Docket Item # 8
BAR CASE #2008-00182

BAR Meeting
November 5, 2008

ISSUE: Permit to Demolish
APPLICANT: Ahmadu Barrie, Owner
LOCATION: 817 King Street
ZONE: KR / King Street Urban Retail Zone

BAR CASE #2008-0182, 0183 11/5/2008

Proposed Rear Elevation

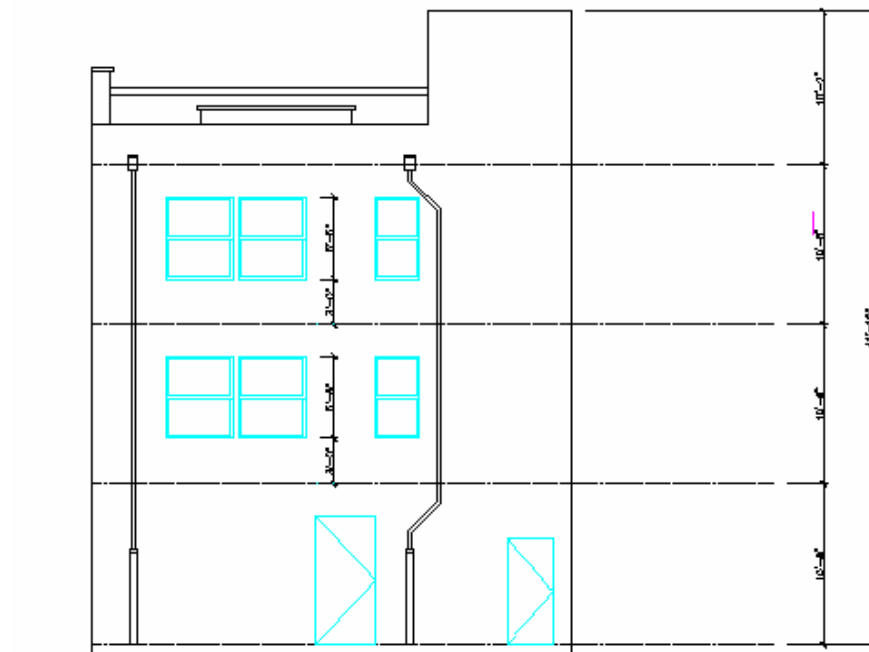
1. Penetrate the existing rear CMU block wall (north elevation) on the subject retail building at 817 King Street to install six (6) new windows. The proposal will remove 101 sq. ft. of the existing block wall to install the new windows, which is approximately 12% of the existing wall surface.
2. Remove an existing 4" high x 3' long threshold at the front entry door to provide an ADA accessible entry.

The proposed demolition does not meet the above criteria, as this proposal will be altering a rear, secondary elevation of a late 1960's building and the removal of the brick threshold will not negatively impact the future integrity of this building. Additionally, the historic district will not be negatively impacted as a result of this approval. It is recommended that the Board support this Permit to Demolish.
